Design Review Board

STAFF REPORT

(For Courtesy Review)

Request: A courtesy review of building/architecture plans for 3 buildings located in Lot 2 of Chadwick Village.

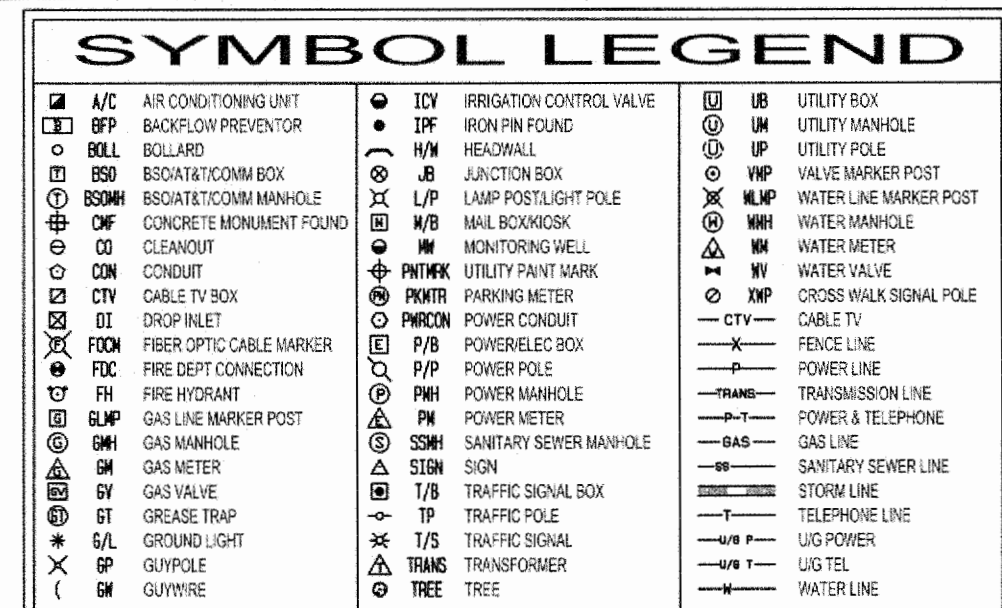
The design features of the buildings depict a modern farmhouse style incorporating rustic architectural elements such as the heavy timber accent framing on the outdoor patio that matches the farmhouse and rustic profile. The overall architecture of the building complements the rural surroundings of the Arnold Mill character area where several large properties fronting the corridor boast equestrian facilities and other agricultural and residential uses that create a rural aesthetic. The proposed architectural elements of the building include brick, board & batten siding, standing seam metal roofs, metal roof awnings at the entrance of each building supported by decorative brackets, an open-air mezzanine, and more. One of the special features of this building is the incorporation of metal mesh screens for vegetation. Below are the concept elevations of buildings 1, 2, and 3.

buildings built to look like barns.		
Roof Must be gable, pyramidal, or hip style. Roof pitches must be between 8 over 12 and 12 over 12 or as approved by the City Architect. Roof material must be made from asphalt shingle, wood shingle, wood shake, or standing seam metal.	The proposed roof is gable style and the material is made from standing seam metal. The roof pitches are 5 over 12 and 6 over 12. These pitches were approved by the City Architect.	Yes
Windows Buildings must have a ratio of openings to solids from 30% to 50%. No one window may exceed 32 square feet. No grouping of windows may exceed 100 square feet or as approved by the City Architect. Windowsills must be placed at least 2 feet above the finished grade. The window must have a vertical orientation.	All windows are fixed windows with different lite patterns ranging from 4 to 10 lite per drawing. The proposed windows are oriented vertically. Window details are limited. Applicant to provide details for staff review before the final review.

Doors Doors used as entryways by the public are limited to wood or simulated wood doors with raised panels; wood or simulated wood doors with raised panels on the bottom half and glass on the top half; glass doors with divided lites.	No specific door details were provided. Applicant to provide details for staff review before the final review.	
Architectural Features Architectural details are required to create variety, visual interest, and texture on new buildings.	The main entrances include brackets, transom over doorways, and projections.

1. Provide details of entrance doors and other exterior doors for each building. This includes height, width, materials, and colors.
2. Provide details of windows for each building. This includes height, width, materials, and colors. Window grid color shall be consistent throughout the building.
3. Identify the colors of brackets. If wooden brackets, the color shall match the heavy timber accent frame located in the exterior patio area.
4. Provide details of balcony railings and other materials used for the balcony/open-air mezzanine.
